CALL NO. 105  
CONTRACT ID NO. 191041  
ADDENDUM # 2

Subject: MASON COUNTY, STP BRO 5462(028)  
Letting July 26, 2019

- (1) Revised - Cover Page - Page 1 of 105
- (2) Revised - Page 4 of 105
- (3) Revised - Special Notes - Pages 21-32(a) of 105
- (4) Revised - Proposal Bid Items - Pages 104-105 of 105
- (5) Added - Geotechnical Engineering Structure Foundation Report Addendum -  
Pages 1-73 of 73
- (6) Revised - Plan Sheets - S1, S21, S22, and S23

**DESCRIPTION US-68**

**APPENDIX B – PILE HEAD LOADS FOR BATTER PILES AT PIERS 2 & 5 FROM  
DOWNDRAG LOADS**

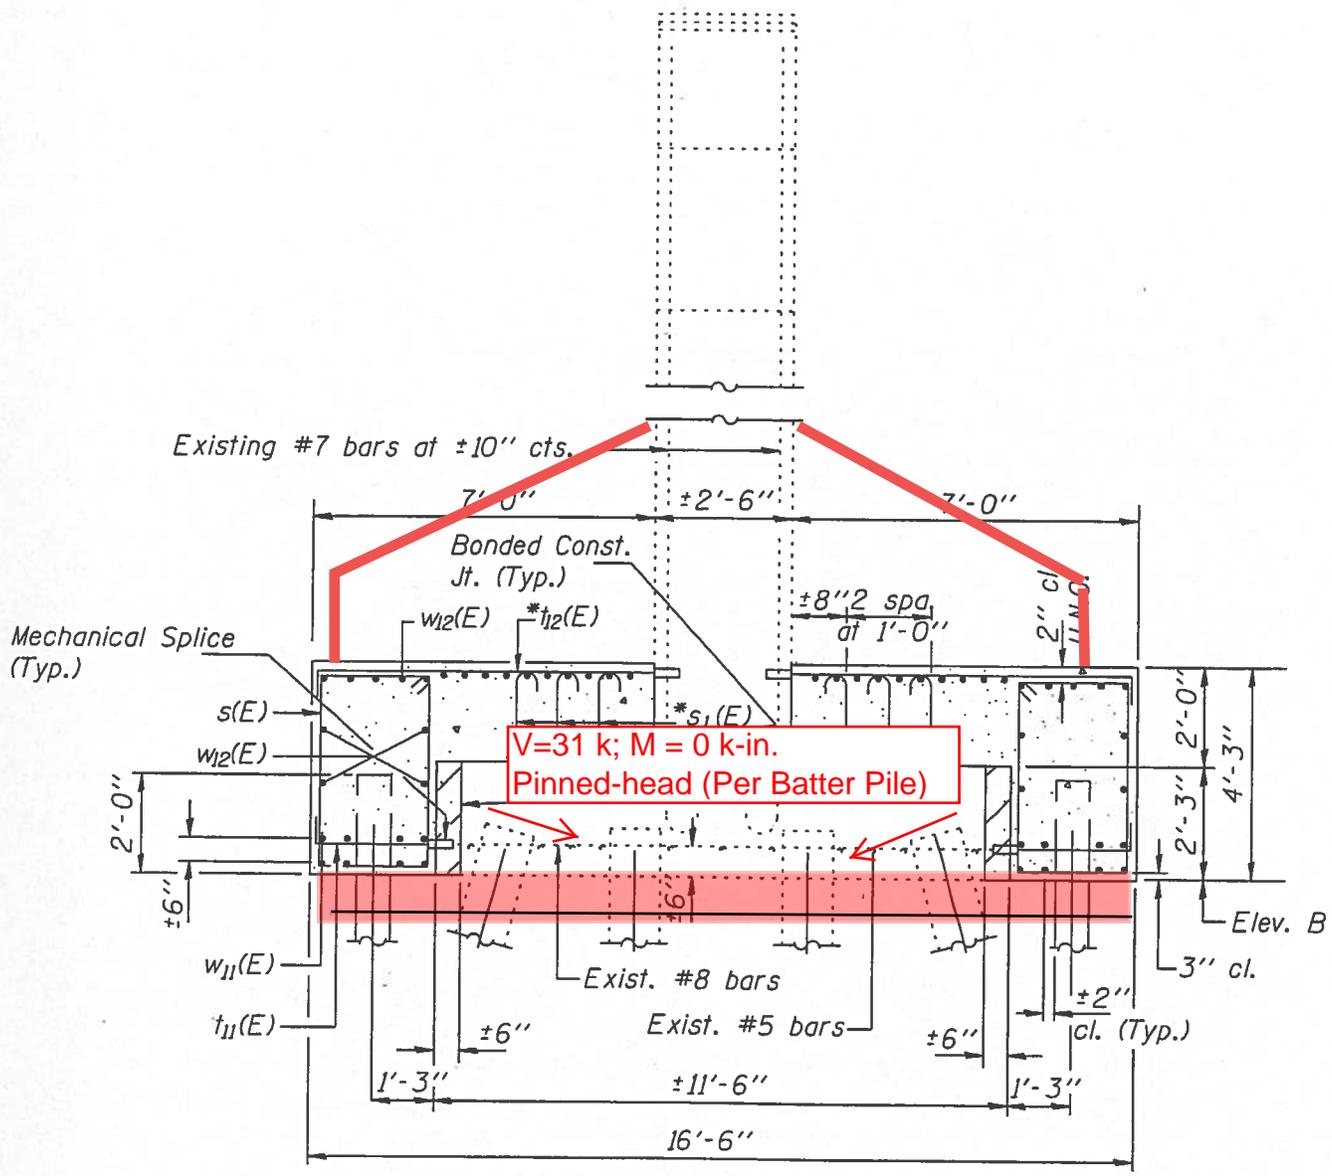
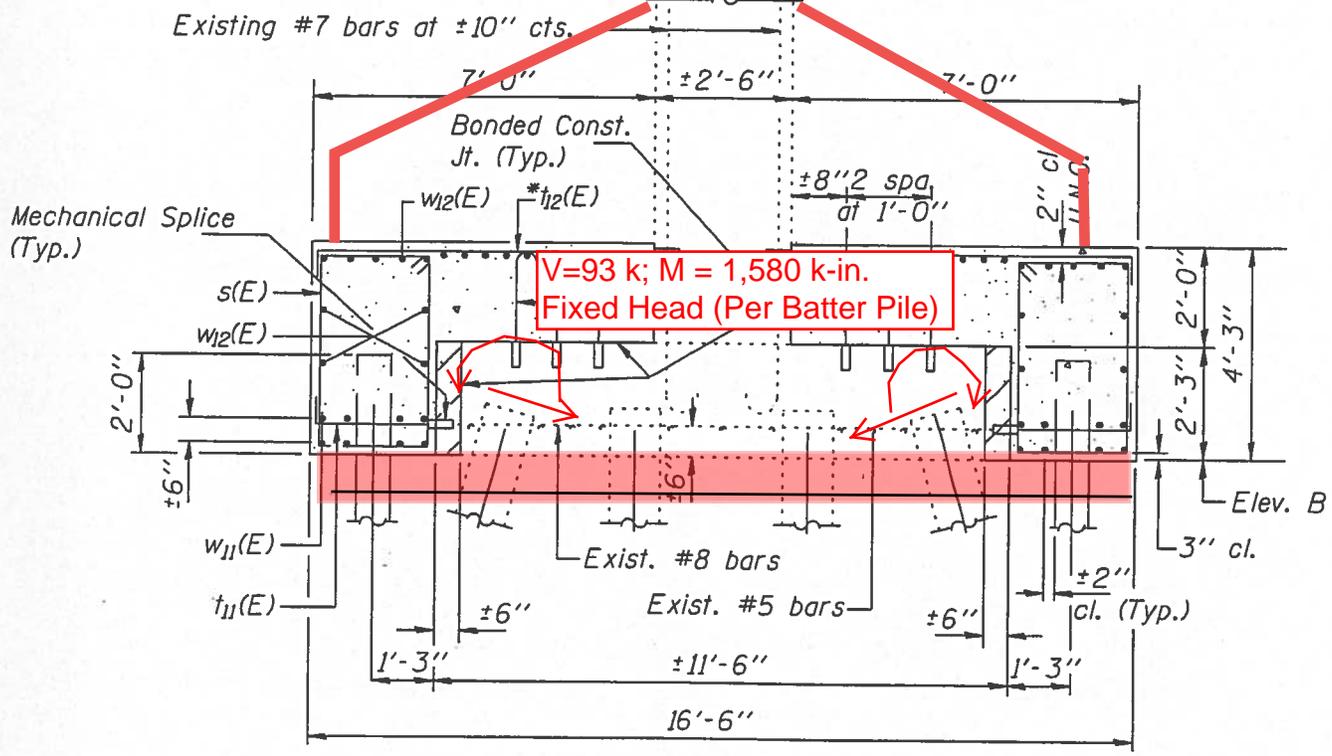
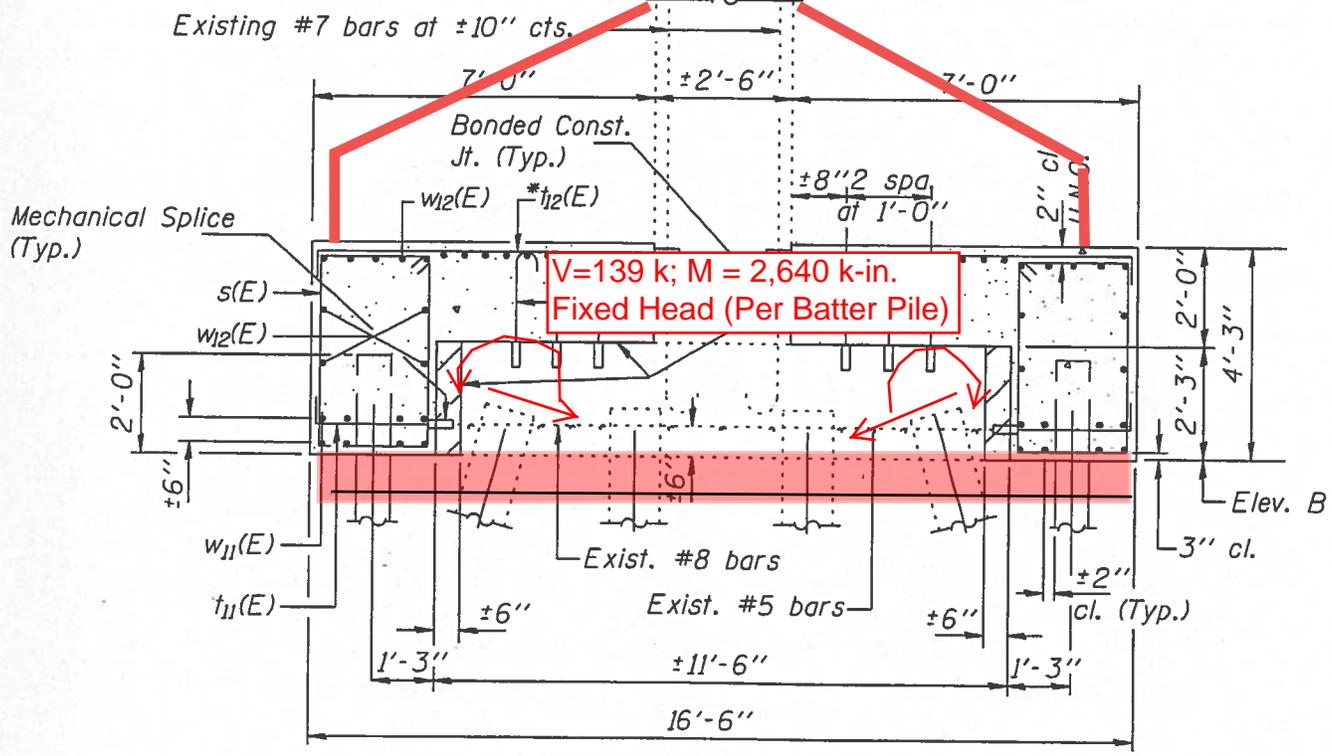
The recommendations provided in Section 10.3 of the Structure Geotechnical Report regarding the batter piles at Piers 2 and 5 should be revised as follows:

- At Piers 2 and 5, we recommend that the existing batter piles be considered insufficient for long-term support of these piers and that any resistance that the batter piles provide be ignored.
- The unfactored pile head shears and moments on the existing batter piles discussed in Section 2.1 of this addendum should be applied to the pile cap in addition to the other loads acting on the pile cap (e.g., the superstructure loads). See the figures in Appendix B for these unfactored loads on a per pile basis.
